MILITARY SPECIFICATION

MODULES, STANDARD ELECTRONIC

INTEGRATOR, S/D, ANALOG, KEY CODE PEG

This amendment forms a part of Military Specification MIL-M-28787/228A(EC), dated 9 September 1982, and is approved for use by the Space and Naval Warfare Systems Command, Department of the Navy, and is available for use by all Departments and Agencies of the Department of Defense.

FIGURE 1. PEG module function diagram, S/D integrator.

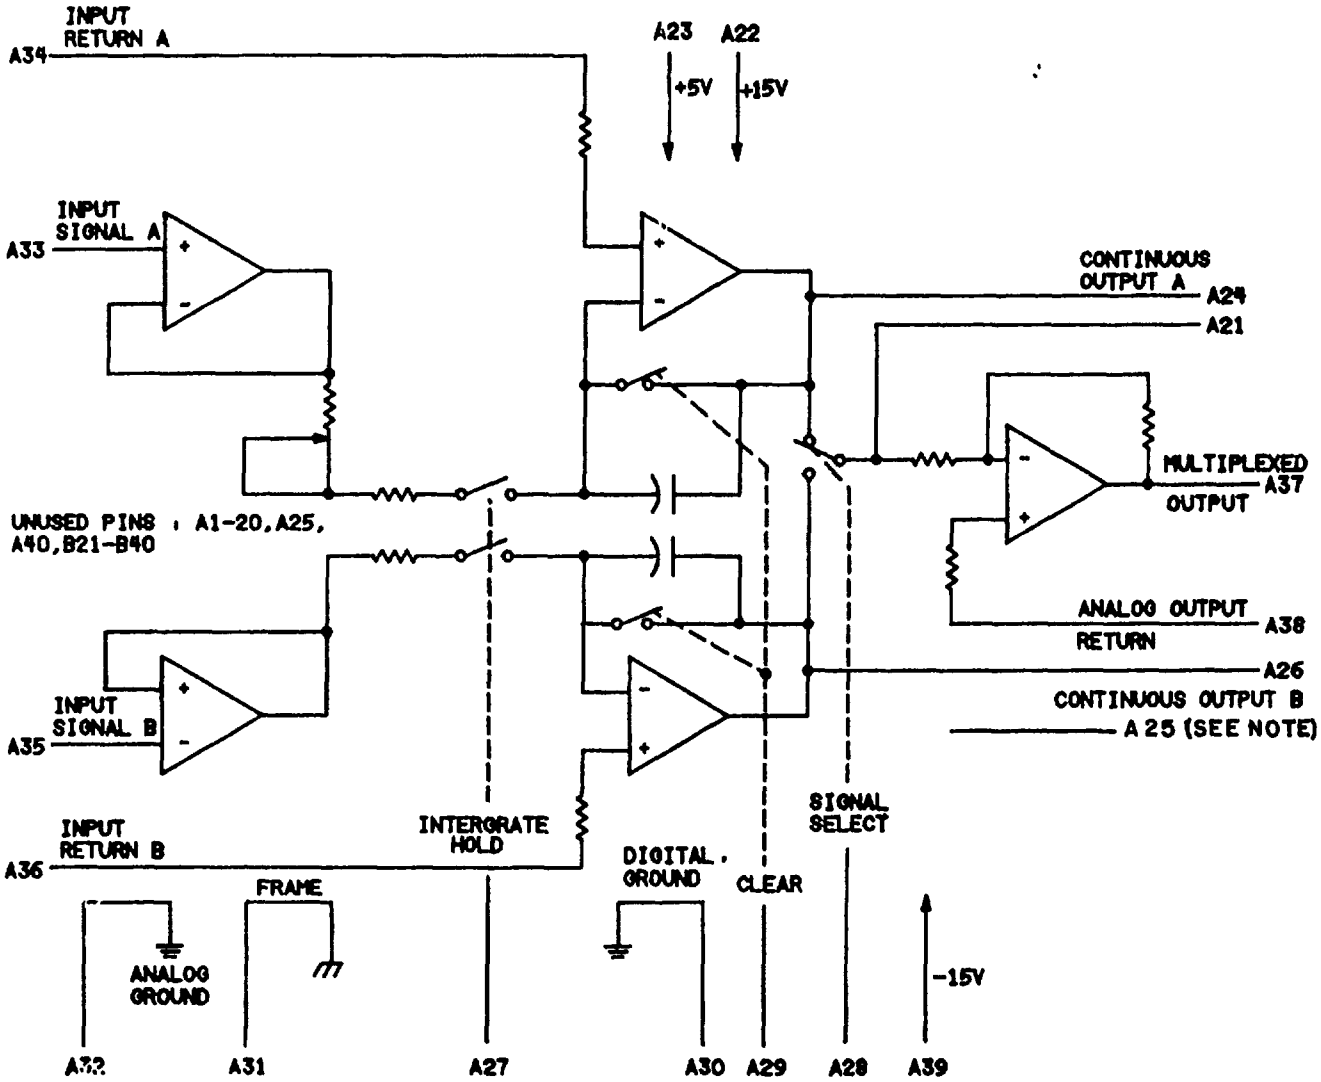
* FIGURE 1: Delete and substitute new figure 1 as printed on page 3 of this amendment.

NOTE: Pin A25 must be connected to pin A38 external to the module for all applications (see 6.4.1).
